United States Nuclear Regulatory Commission
Enclosure 3 to Serial: RNP-RA/96-0141
Page 1 of 3

H. B. ROBINSON STEAM ELECTRIC PLANT, UNIT NO. 2
APPLICATION OF SELECTION CRITERIA

**APPLICATION OF SELECTION CRITERIA TO THE
H. B. ROBINSON STEAM ELECTRIC PLANT UNIT NO. 2
TECHNICAL SPECIFICATIONS**

CORE PROTECTION BOUNDARIES FOR S-LOOP OPERATION
Figure 2.1-1

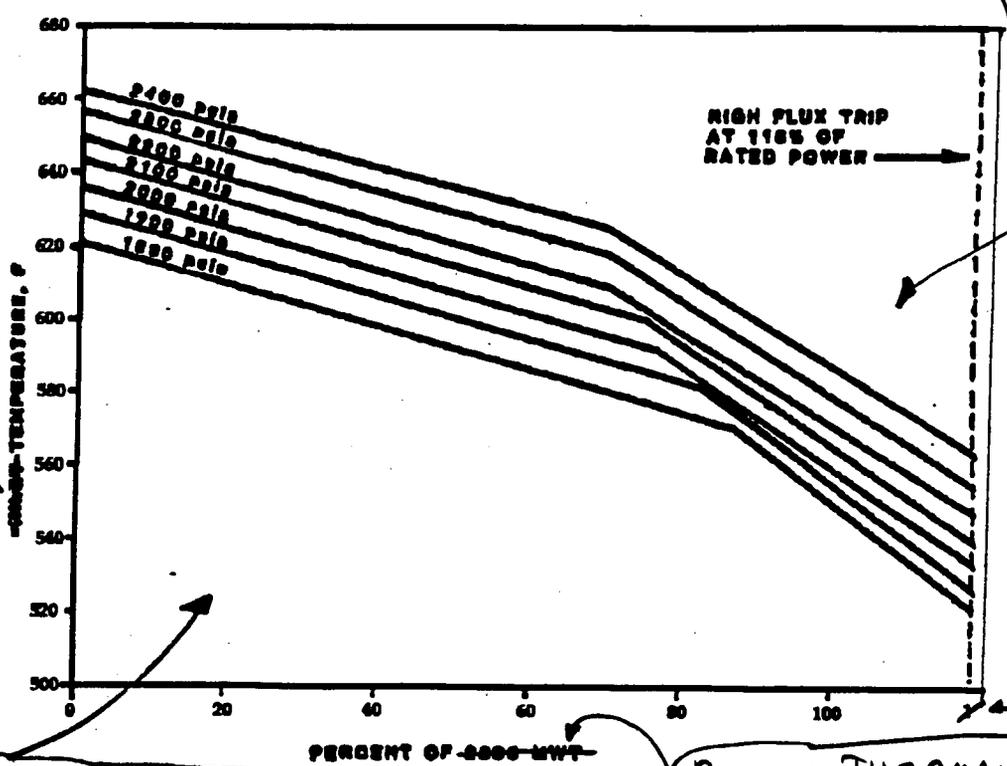
- A2 The CTS 2.1 reactor core SL Specification is not stated in terms of a specific point for the temperature measurement, however the referenced CTS Figure 2.1-1 is specified in terms of inlet (i.e., cold leg) temperature. The ITS specifically describes the SL in terms of the highest RCS cold leg temperature. The addition of the specific reference to ". . . highest cold leg temperature . . ." is an administrative detail added for clarity.

- A3 CTS 2.1.d is not retained in the ITS. CTS 2.1.d provides administrative details defining when the SLs specified in Figure 2.1-1 and in CTS 2.1.b and 2.1.c are exceeded. This type of clarification is included in the comparable ITS Figure 2.1.1-1. See A4 for additional information. The additional administrative detail regarding CTS 2.1.b and 2.1.c merely reiterate that violating the specified limits is exceeding the SLs. This change is consistent with NUREG-1431.

- A4 CTS Figure 2.1-1 does not clearly define the regions of acceptable and unacceptable conditions. Administrative clarifications are included in ITS to delineate the appropriate regions on the figure. This change is consistent with NUREG-1431.

Figure 2.1.1-1 (page 1 of 1)
Reactor Core Safety Limits

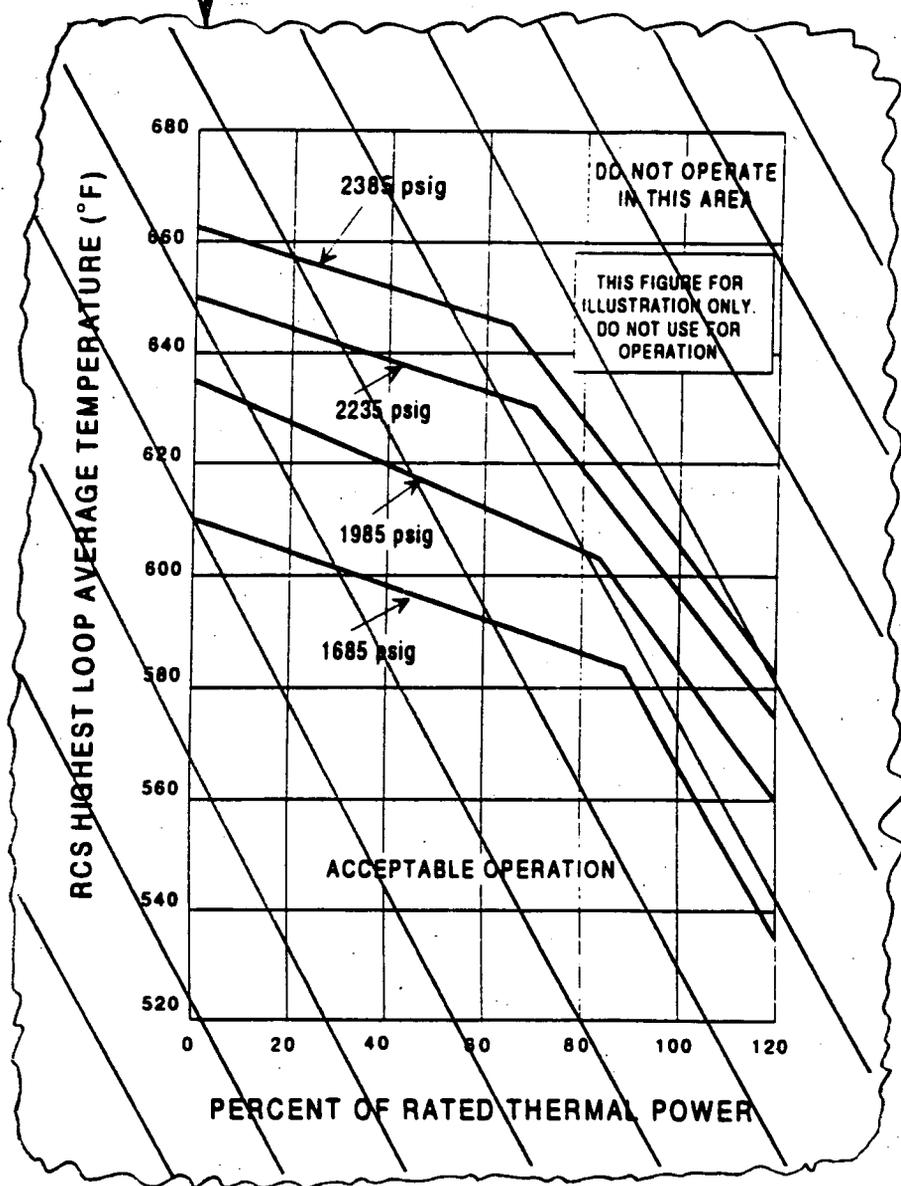
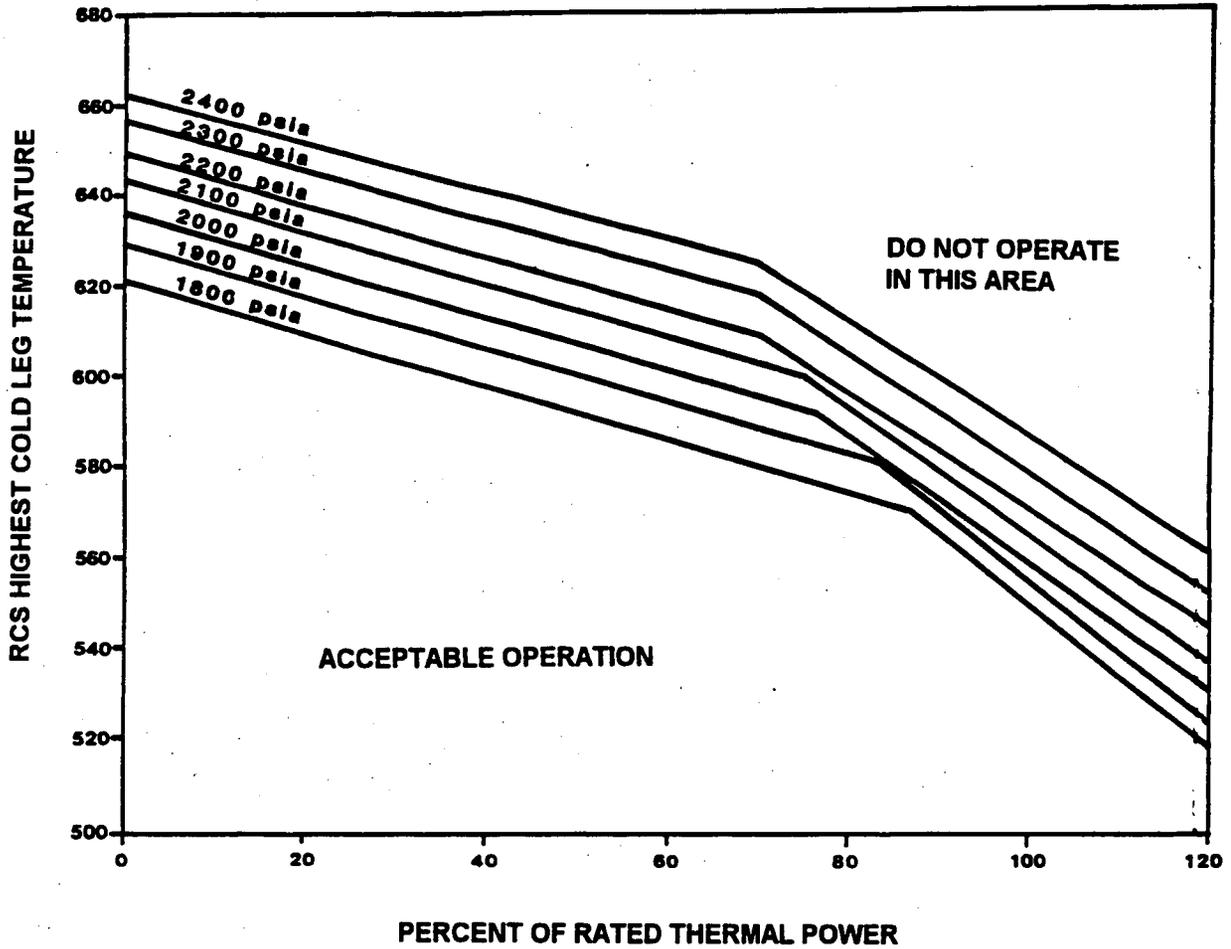
1. ISTS 2.1.1 utilizes the "RCS highest loop average temperature" as one of the bounding parameters for the reactor core SLs. ITS 2.1.1 uses the "RCS highest cold leg temperature" to preserve consistency with the current licensing basis, specifically the limits specified in CTS figure 2.1-1. There is no material difference between the ITS SL curve expressed as a function of cold leg temperature and the ISTS curve expressed as a function of RCS average temperature. The limits specified in CTS figure 2.1-1 do not specifically state in which loop the RCS cold leg temperature measurement is made. The delineation of the use of the highest value for the three RCS cold leg temperatures in the ITS is conservative, since use of this value bounds the conditions in the remaining loops with respect to impact on the fuel SLs.

NOTE: BASED ON A MINIMUM RCS FLOW OF 97.3×10^6 lbm/hr

Figure 3.10-2 SHUTDOWN MARGIN VS BORON CONCENTRATION

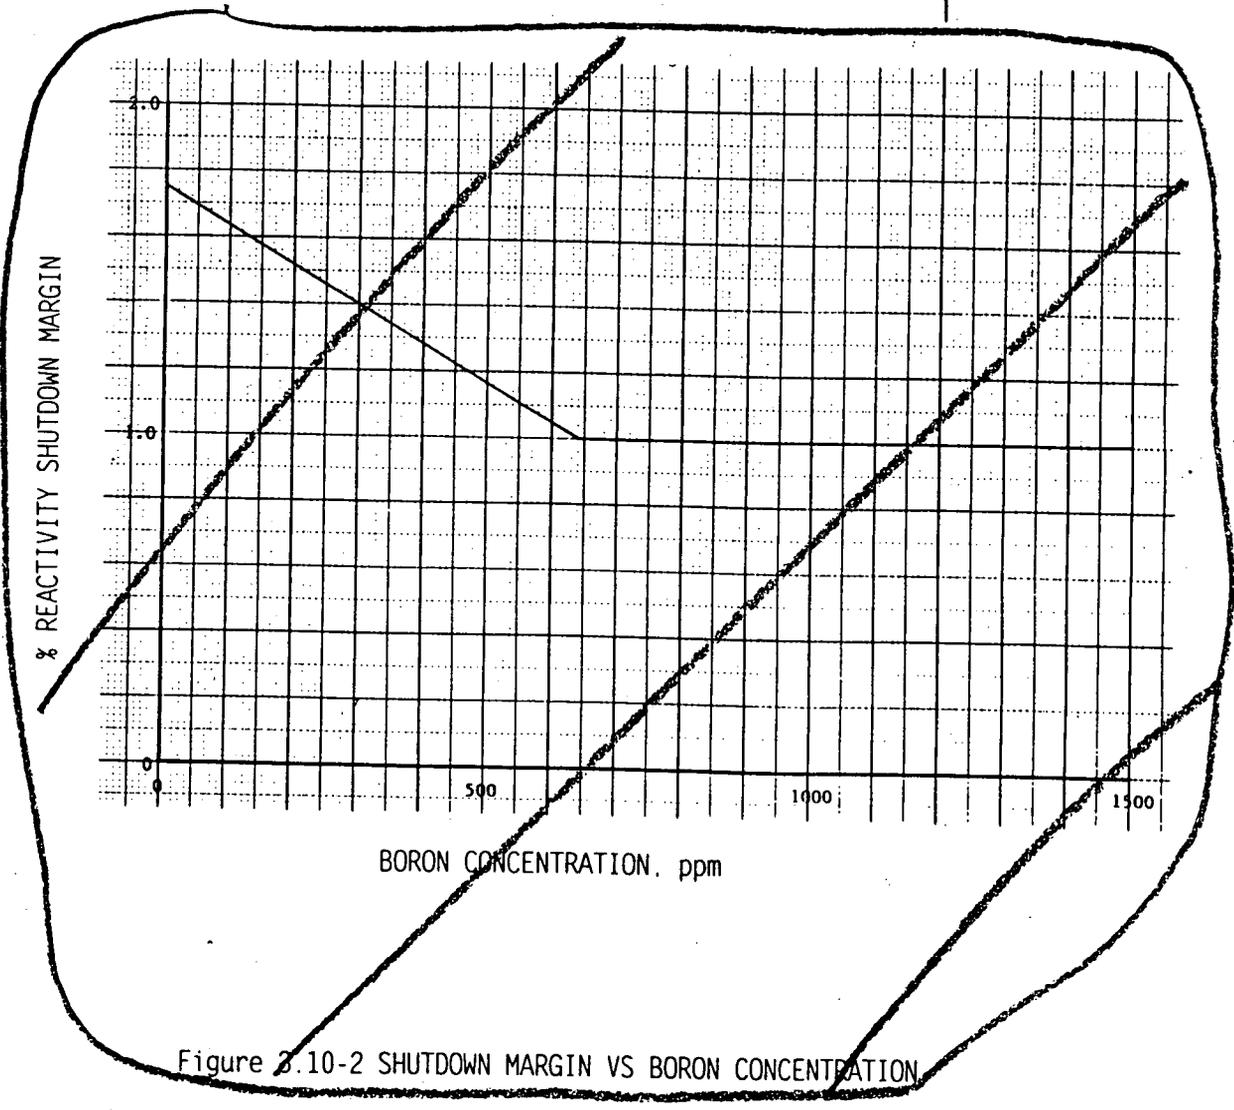
- A2 CTS 3.10.8.1 requires that the shutdown margin (SDM) be within the limits specified in figure 3.10-2 when the reactor is in hot shutdown. CTS 3.10.8.2 requires that the SDM be at least 1 percent $\Delta k/k$ when the reactor is in cold shutdown. ITS 3.1.1 specifies that the SDM be maintained within the limits provided in the Core Operating Limits Report (COLR) with a specified applicability of MODE 2 with $k_{\text{eff}} < 1.0$ and MODES 3, 4 and 5. The CTS definition of hot shutdown encompasses ITS MODE 2 with $k_{\text{eff}} < 1.0$ and ITS MODES 3 and 4. The CTS definition of cold shutdown is consistent with ITS MODE 5. Therefore, this is an administrative change resulting from combining CTS Specifications 3.10.8.1 and 3.10.8.2.

- LA1 CTS Specifications 3.10.8.1, 3.10.8.2, and Figure 3.10-2 provide required shutdown margin values. CTS Specification 3.10.1.4 requires control rod insertion limits be adjusted to the end-of-core values as provided in the COLR at 50 percent of the cycle. These details are not retained in the ITS and are relocated to licensee controlled documents.

Figure 3.1.4-1 (page 1 of 1)
Moderator Temperature Coefficient vs. Power Level

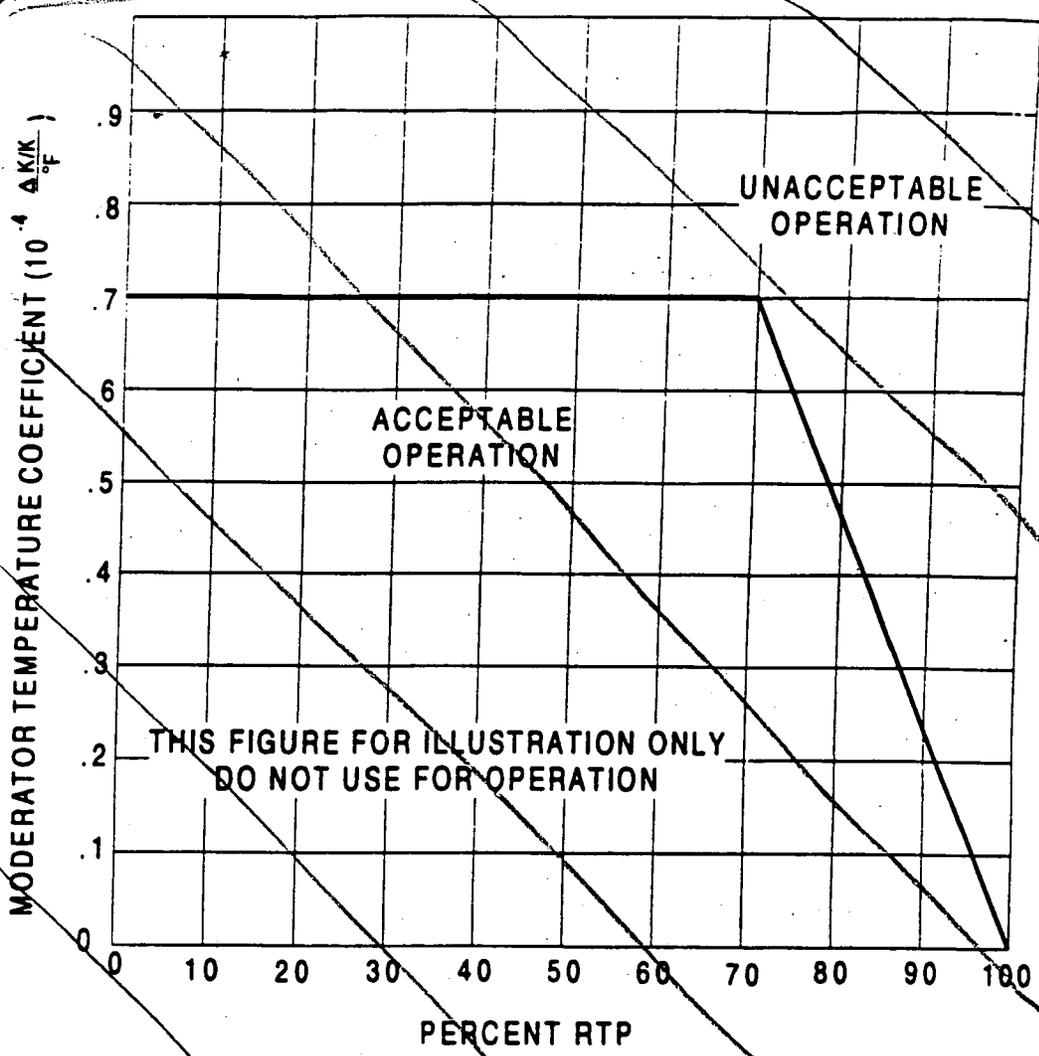
- 3 ISTS Figure 3.1.4-1 is not used in the ITS. The maximum upper limit for MTC consists of two values specified in ITS 3.1.3, obviating any need for the Figure.

Figure B 3.1.1 (page 1 of 1)
Control Bank Insertion vs. Percent RTP

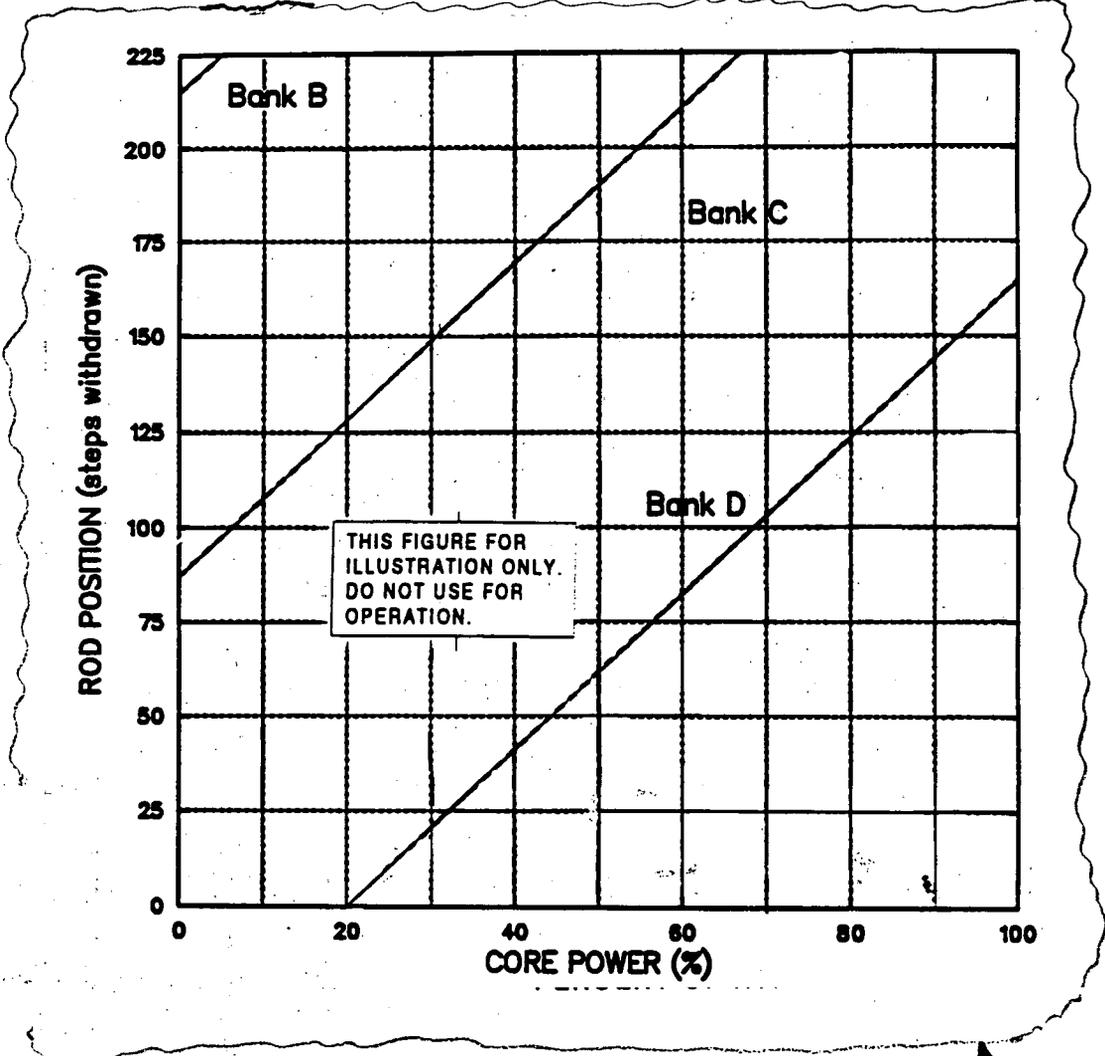
- 33 Plant specific values are inserted in the Bases 3.1.6 discussion. A different example Figure B 3.1.6-1 is inserted to reflect that maximum rod withdrawal is 225 steps, and not 231 steps.
